Water Management Plan Update Process Participant comments and information requests received between May 22 and Aug. 15, 2025, and LCRA responses

Comments and information requests are summarized, followed by LCRA's responses. Written comments submitted during this period are included in their entirety at the end of this document.

Water Management Plan Update Process Participant comments received between May 22 and Aug. 15, 2025

(A)

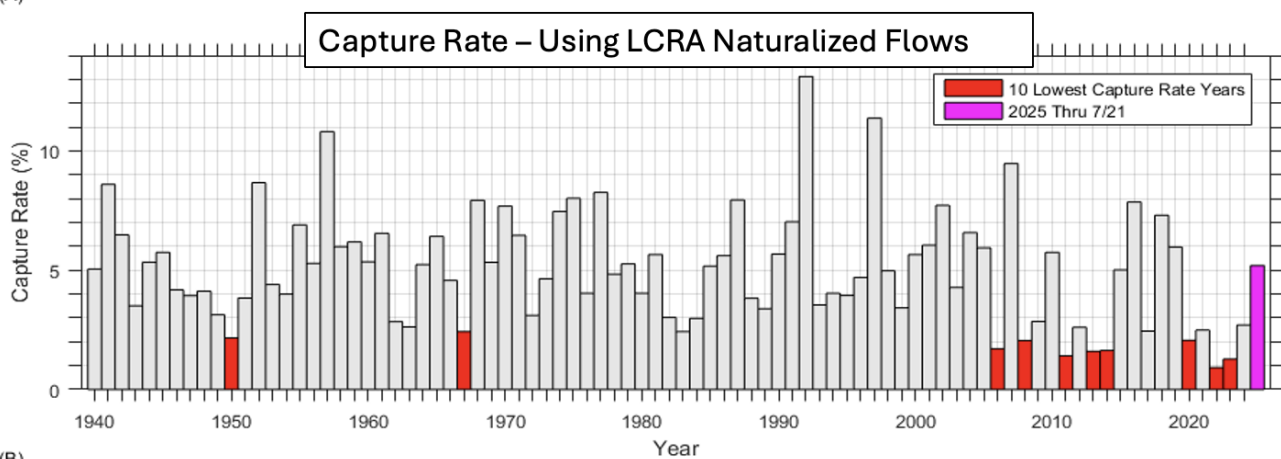
- **Need to Prepare for More Severe Droughts:** While the 2008–2015 drought currently serves as the Drought of Record, historical data shows that rainfall during the 1950s drought was significantly lower. That lower historical rainfall also resulted in higher inflows in the 1950s than is currently produced by the watershed under similar rainfall conditions. This phenomenon is vividly illustrated in the graphic below.

With today's diminished watershed productivity, according to CTWC research, a repeat of 1950s rainfall conditions coupled with today’s watershed productivity would likely result in a critical water supply shortage. Raising the minimum storage threshold (from 600,000 acre-feet to 750,000 acre-feet) is a key step toward protecting against this valid and increasingly threatening concern.

Figure 1a: Depletion of WAM-Modeled Combined Storage (2020 WMP & 2025 WMP) compared to actual observed storage from 2007-2017

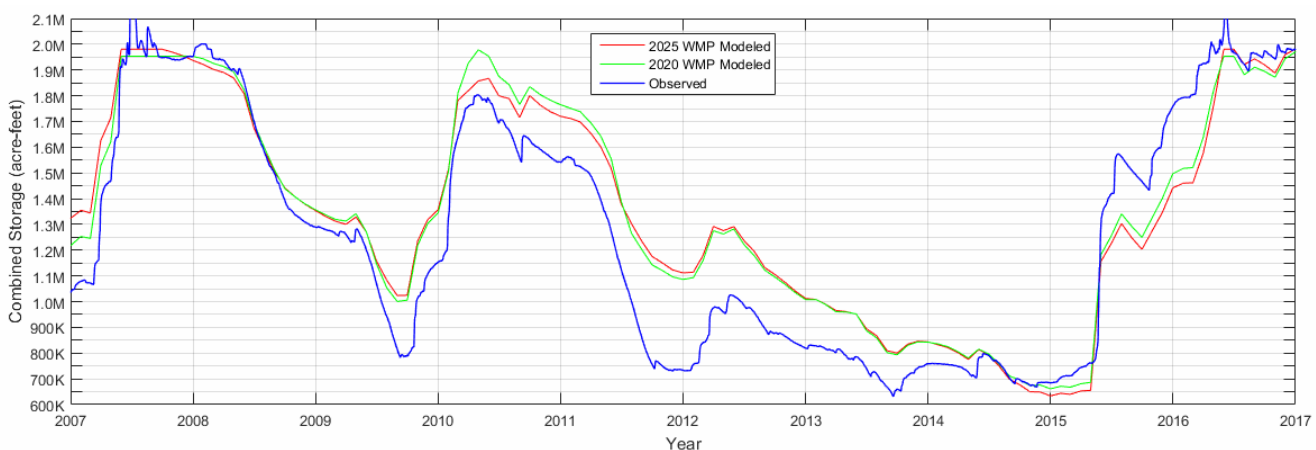
- **Rapid Drawdowns in Modeling:** Our analysis of the WAM outputs based on LCRA's proposed parameters suggests that combined storage can again drop to critically low levels within just 3–4 years. This is particularly alarming when storage dips below 1 million acre-feet, as a repeat of low inflows—such as those experienced in 2022–2023—could leave the system highly vulnerable. According to CTWC WAM runs, the pattern of rapid depletion closely mirrors the risk experienced during the most recent drought cycle (Figure 1a). In fact, modeled combined storage would be lower at the end of 2023 than observed during the current and ongoing drought period (Figure 1b)

Figure 2: 1950s Drought becomes controlling with naturalized flow adjustment based on capture rate – Estimated Adjusted Firm Yield = 234,000 acre-ft/year

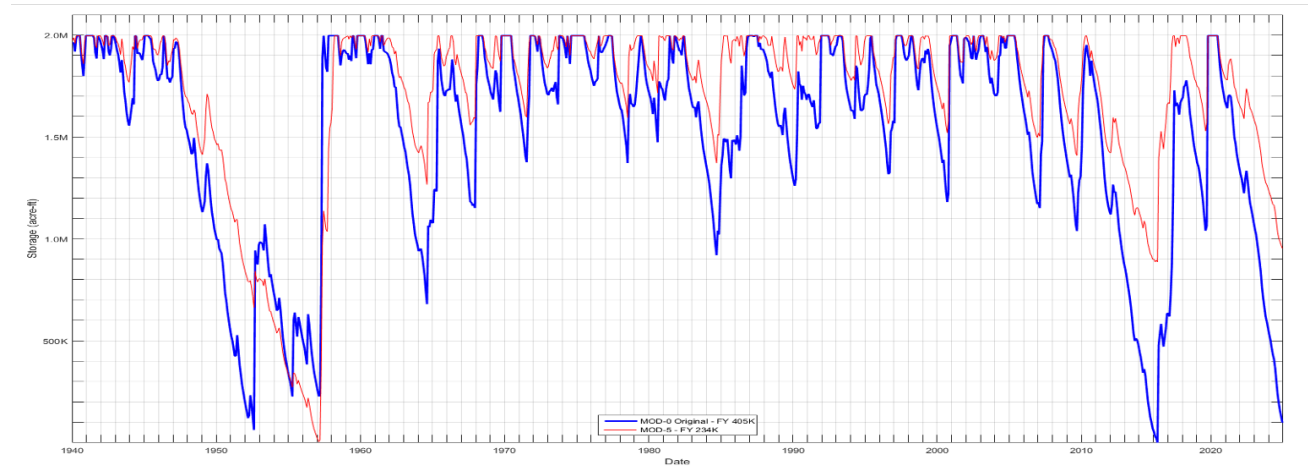
- Adopt a more conservative safe yield approach that reflects today’s reduced inflows, declining watershed productivity, and the possibility of droughts more severe than the 2008–2015 drought of record.
- CTWC research indicates that firm yield could be as low as 234,000 acre-feet if the exceptionally low rainfall of the 1950s drought were to recur under current watershed conditions. This estimate is based on adjusted naturalized flows that incorporate historical rainfall from the 1950s and apply modern assessments of watershed productivity to reflect present-day realities (Figure 2).

LCRA will continue calculating a firm yield for lakes Buchanan and Travis and its other water rights and using those values for contracting purposes. The WMP will continue to include a buffer for a potential drought worse than the Drought of Record by maintaining a minimum combined storage of above 600,000 acre-feet through a modeled repeat of the historic period (1940-2023), which includes the Drought of Record (2008-2015).
